MONTGOMERY COUNTY HISTORIC PRESERVATION COMMISSION
STAFF REPORT

Address:	7314 Maple Ave., Takoma Park	Meeting Date:	1/14/2015
Resource:	Contributing Resource Takoma Park Historic District	Report Date:	1/7/2015
Applicant:	Kenneth Burton & Matthew Castrina	Public Notice:	12/31/2014
		Tax Credit:	Partial
Review:	HAWP	Staff:	Michael Kyne
Case Number:	37/03-14GG (REVISION)

PROPOSAL: Replace non-original siding, replace asphalt shingle roof, remove rear porch addition, construct two-story rear addition, and return front porch to original condition

ROOF PLAN – PROPOSED

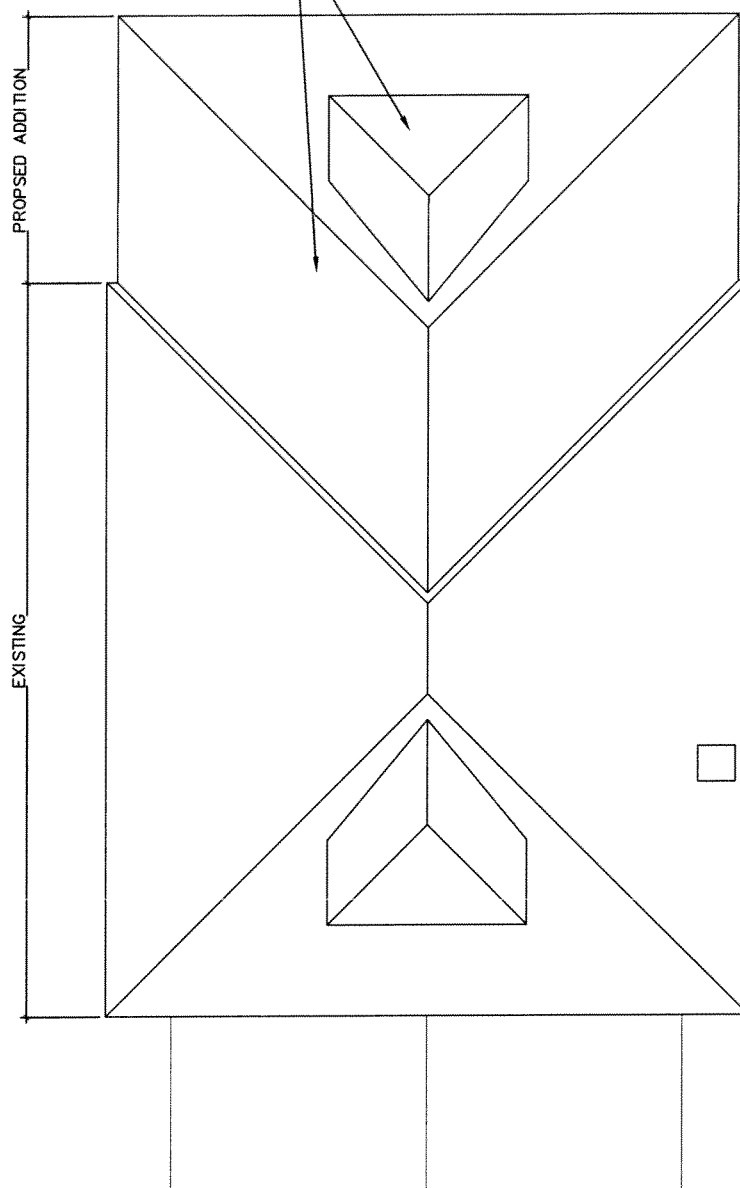
- The ridgeline of the proposed rear addition gable roof will be slightly lower than the existing roof.
- The existing siding to be replaced is non-original and non-historic.

- As previously recommended by the HPC, the proposed rear addition roof form resembles the existing hipped roof form.

ELEVATION – EAST (FRONT)

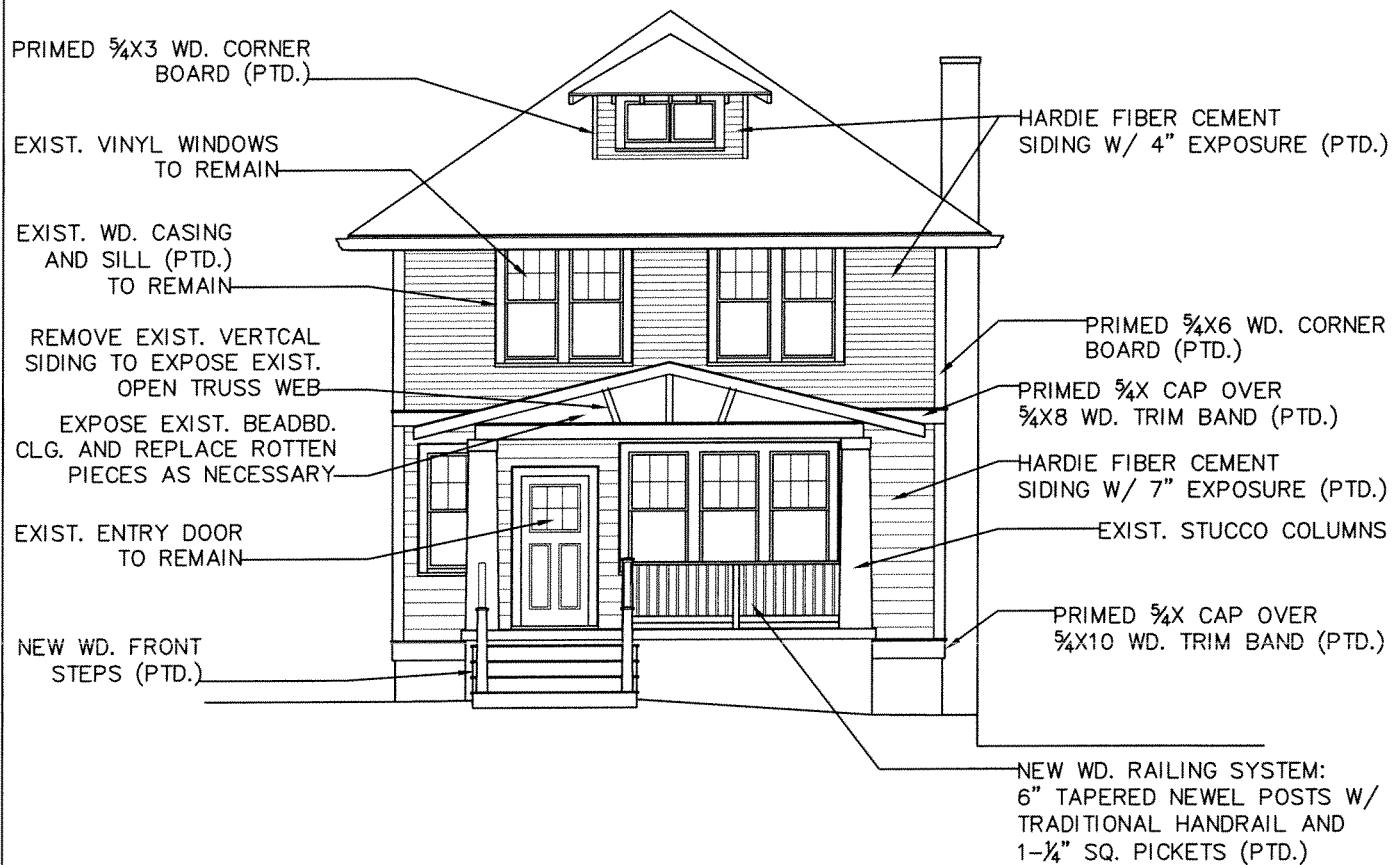
Staff finds that the proposed alterations to the front porch are compatible with the existing structure and surrounding streetscape. The applicants will remove non-original, non-historic siding from the front porch gable, returning the porch to its original condition. The applicants will also install a porch railing and stairs that are compatible with the existing structure and neighboring properties. Therefore, staff finds that the proposed front porch alterations are consistent with the *Guidelines*.

ELEVATION - WEST (BACK)

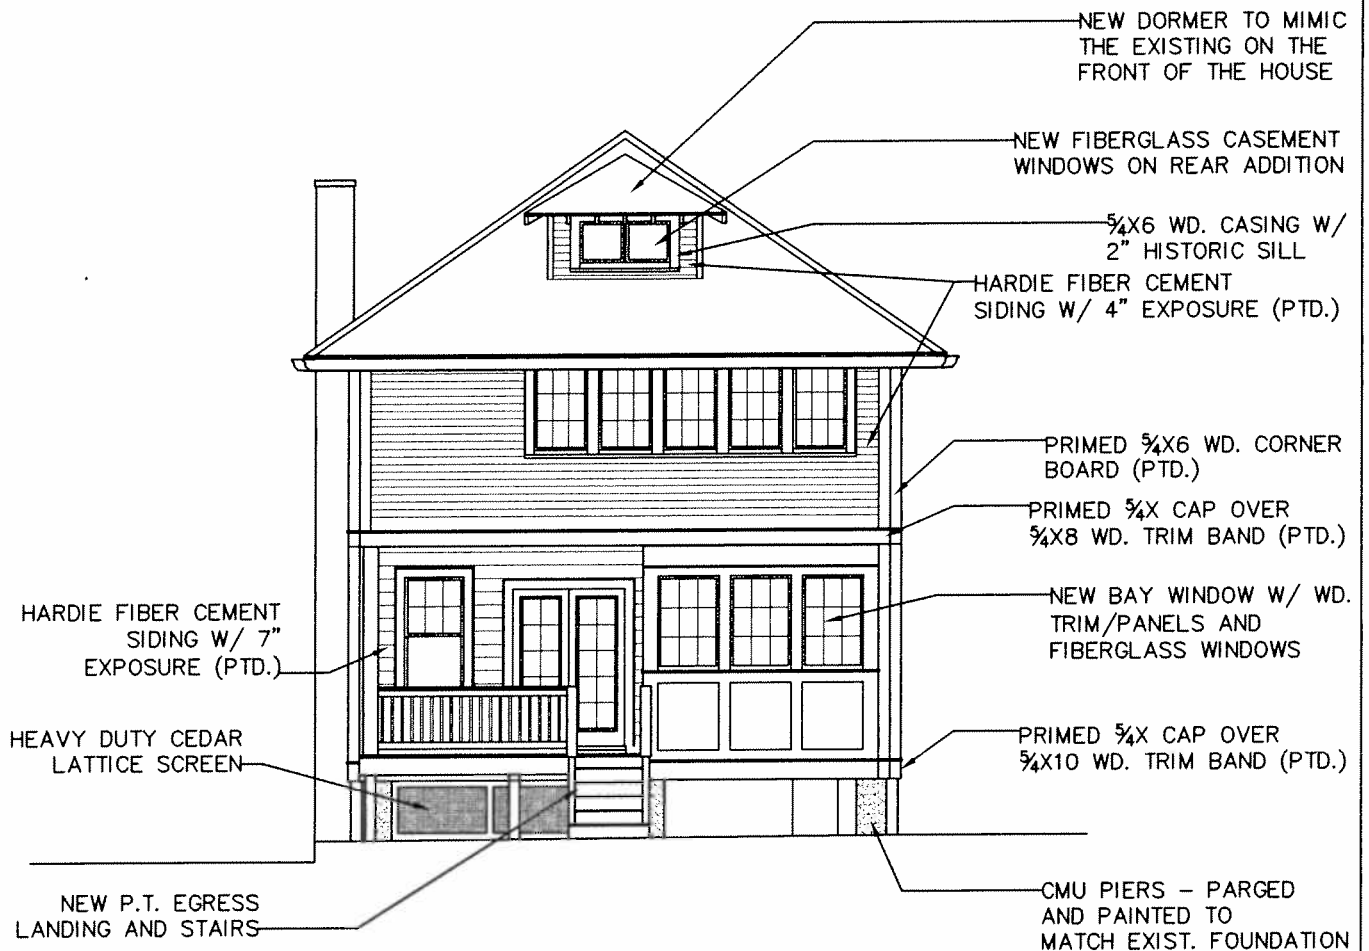
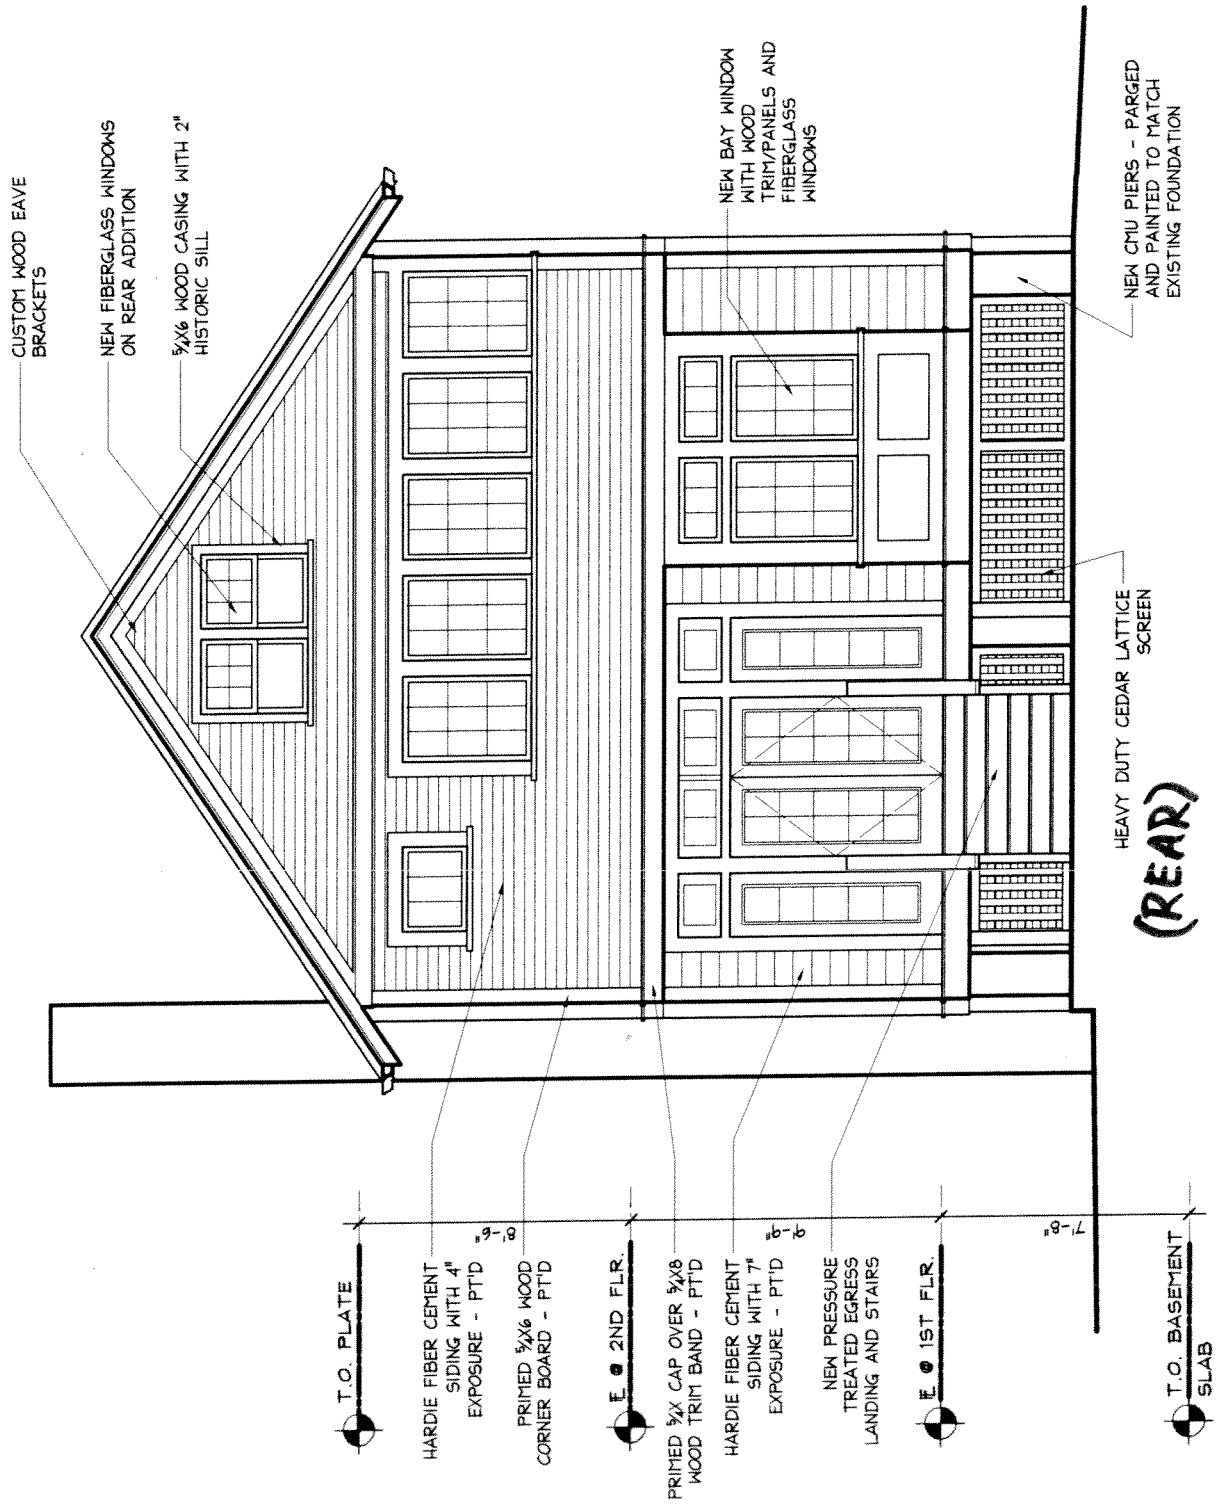
Staff finds that the rear addition, as revised, is more compatible with and sympathetic to the character of the historic house than the previous proposal. The applicants addressed the HPC's concerns regarding the previously proposed roof form and have altered their proposal so that the rear addition roof will be more compatible with the historic house and appear less massive.

In the previous staff report, it was noted that the HPC may find that the second floor casement windows on the south and rear elevations should not extend to the corners. While the HPC approved the previously proposed windows without conditions, the applicants addressed these potential concerns with their revised proposal.
